EAST TOWN CROSSING
BUILDING 'D'
PIONEER & SHAW PUYALLUP WA

TITLE: SITE PLAN REF ONLY

AS1.0

AGENCY REVIEW - REVISION No.1 | 24.10.28

4 OVERALL SITE PLAN - PHASE 1 & 2
SCALE: 1" = 40'

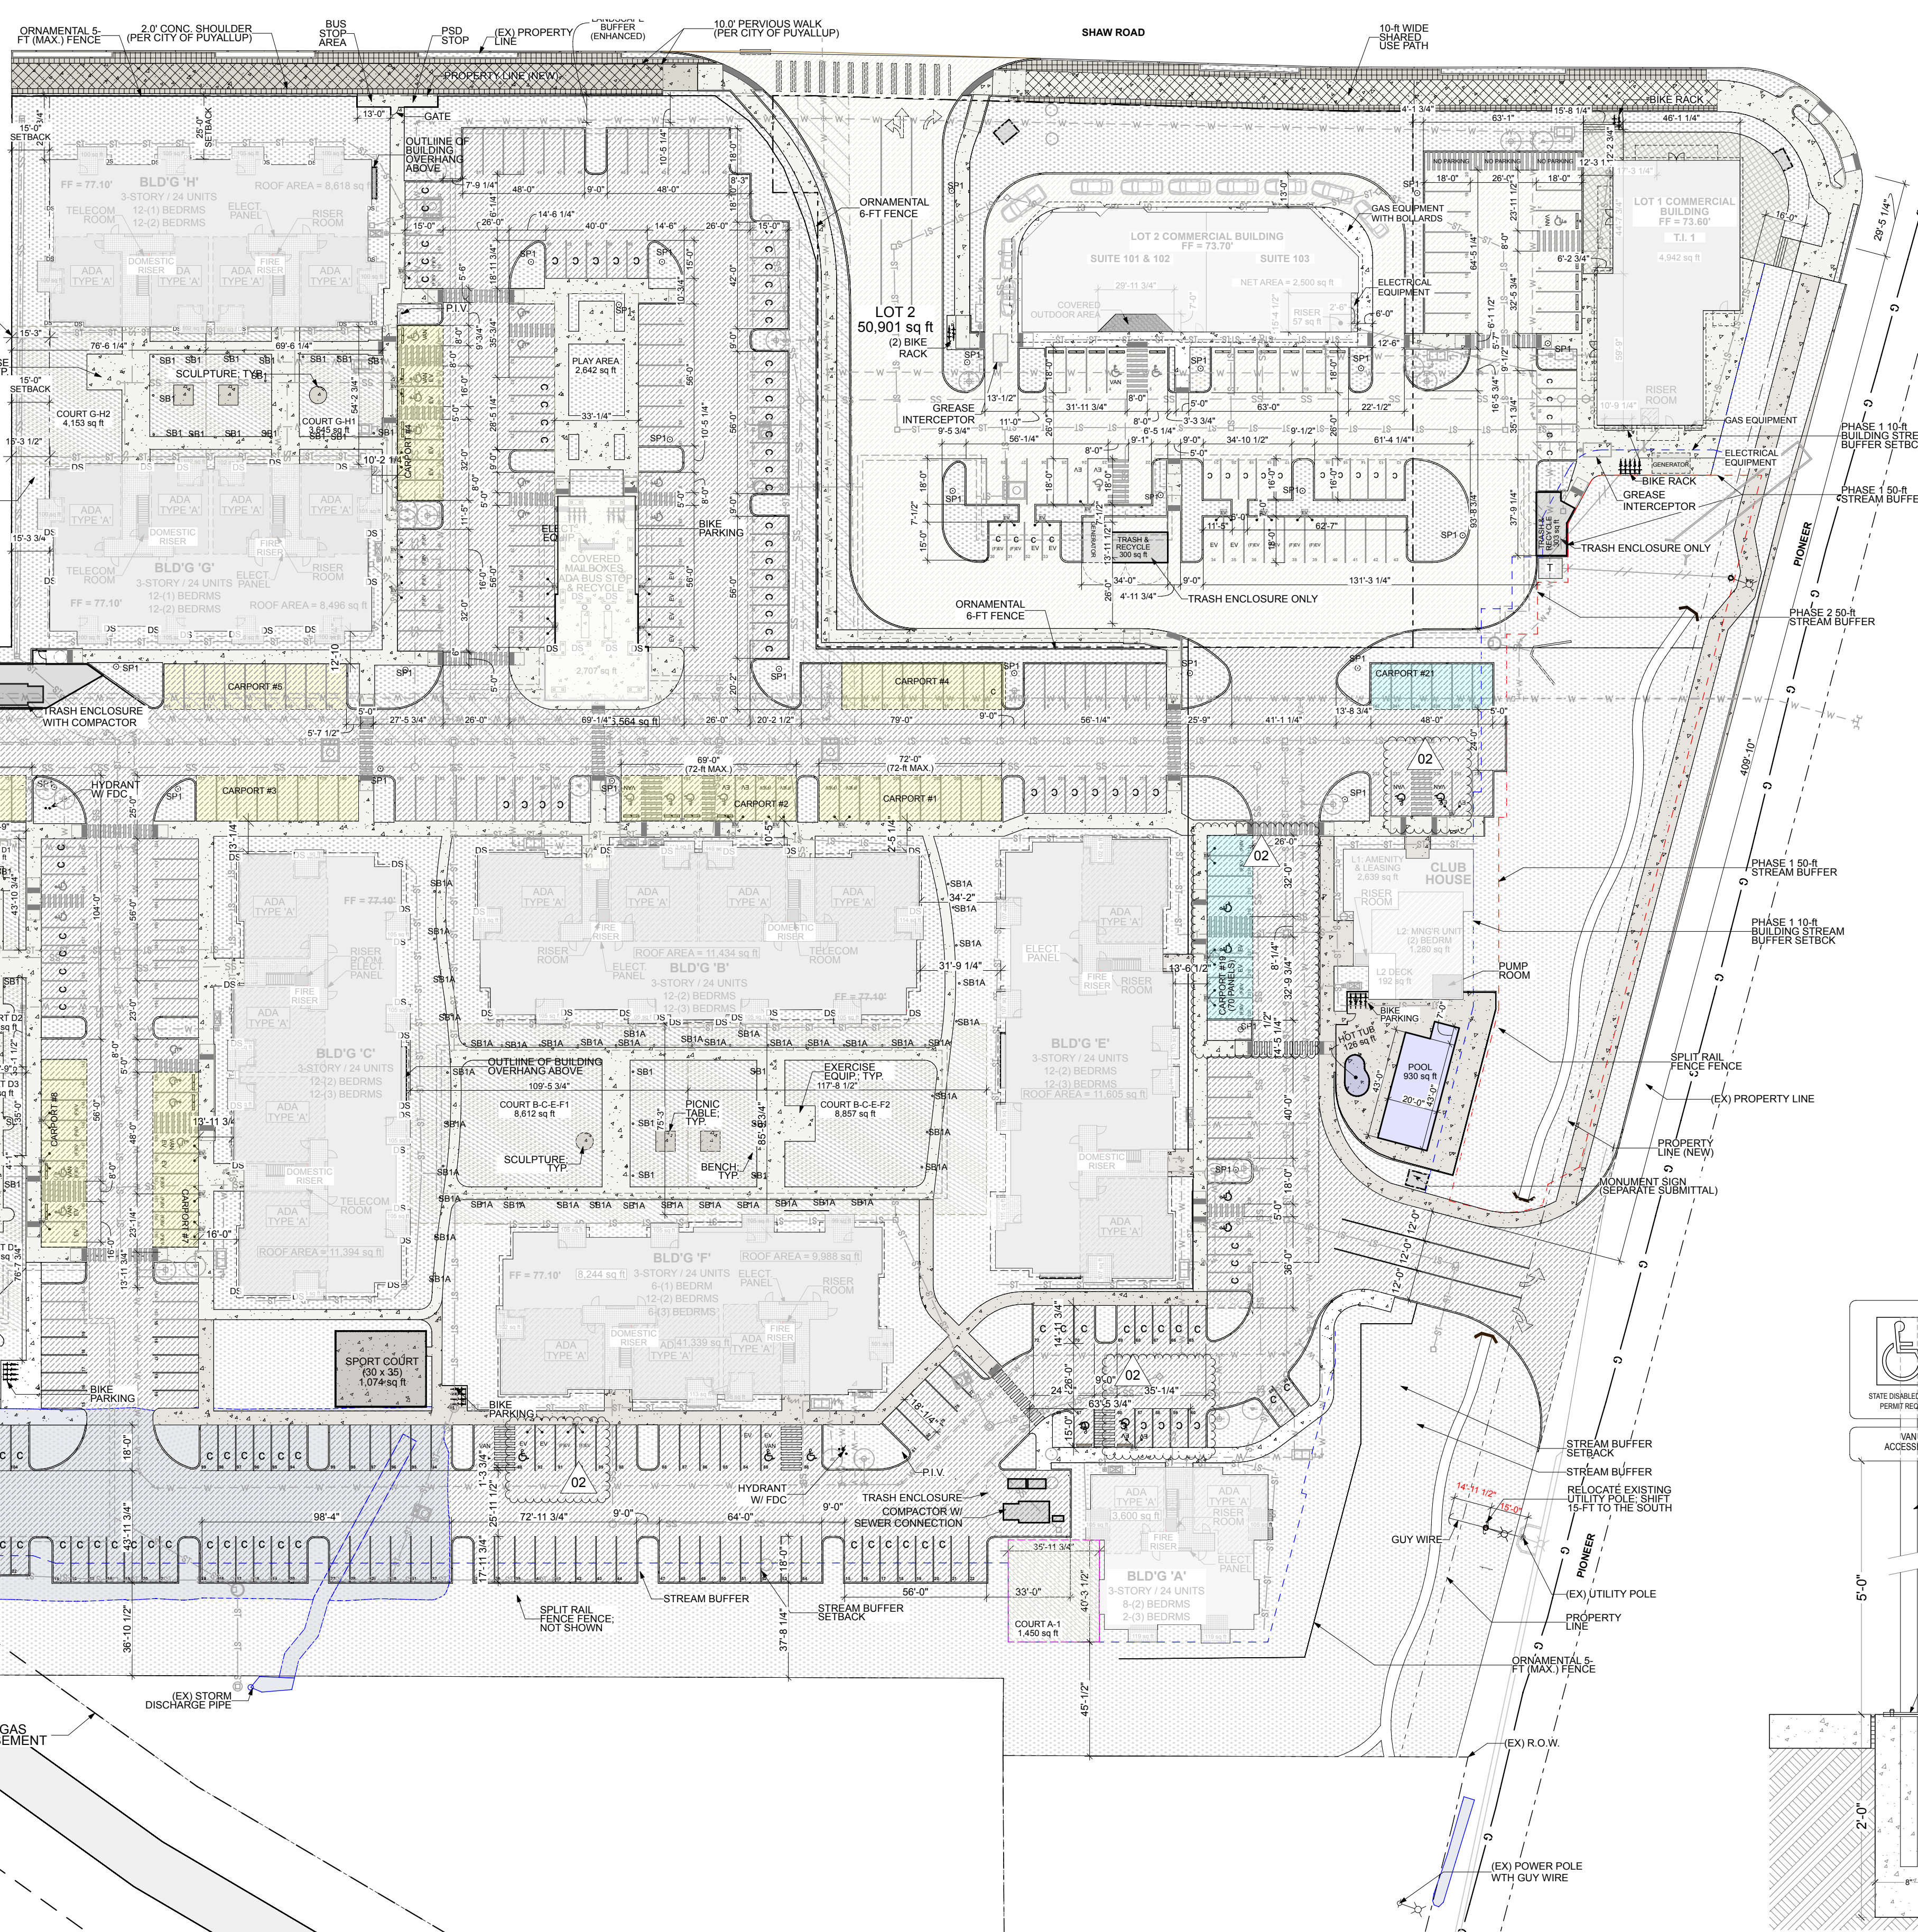
The applicant shall request a sediment control and erosion inspection with a City Engineering Inspector through the CityView portal at least 48 hours in advance of job start. Refer to the Stormwater Fact Sheet and City Standards 02.03.02 & 05.02.01

Sediment control and erosion procedures shall be practiced eliminating and preventing off site damage. Stormwater runoff originating upgrade of exposed areas shall be controlled to reduce erosion and sediment loss during the period of exposure. See civil permit PRCCP20230970 for specifications

Roof downspout control is required. Steps shall be taken to prevent drainage onto adjacent lots. See civil permit PRCCP20230970 for specifications

20' setback
from south P/L

TYPICAL AT EACH APARTMENT BUILDING
A stand of trees with a canopy of 1,000 square feet (as measured in frontal view rather than top view) located no farther than 20 feet from a facade of the building, consisting of either existing trees, or planted trees.
(Per PMC 20.26.200 (4) (b) (v))

The applicant is responsible to show onsite private utilities services for each building on a site plan. This includes sewer or septic, storm and water. [Site Plan Sheet 1 of]
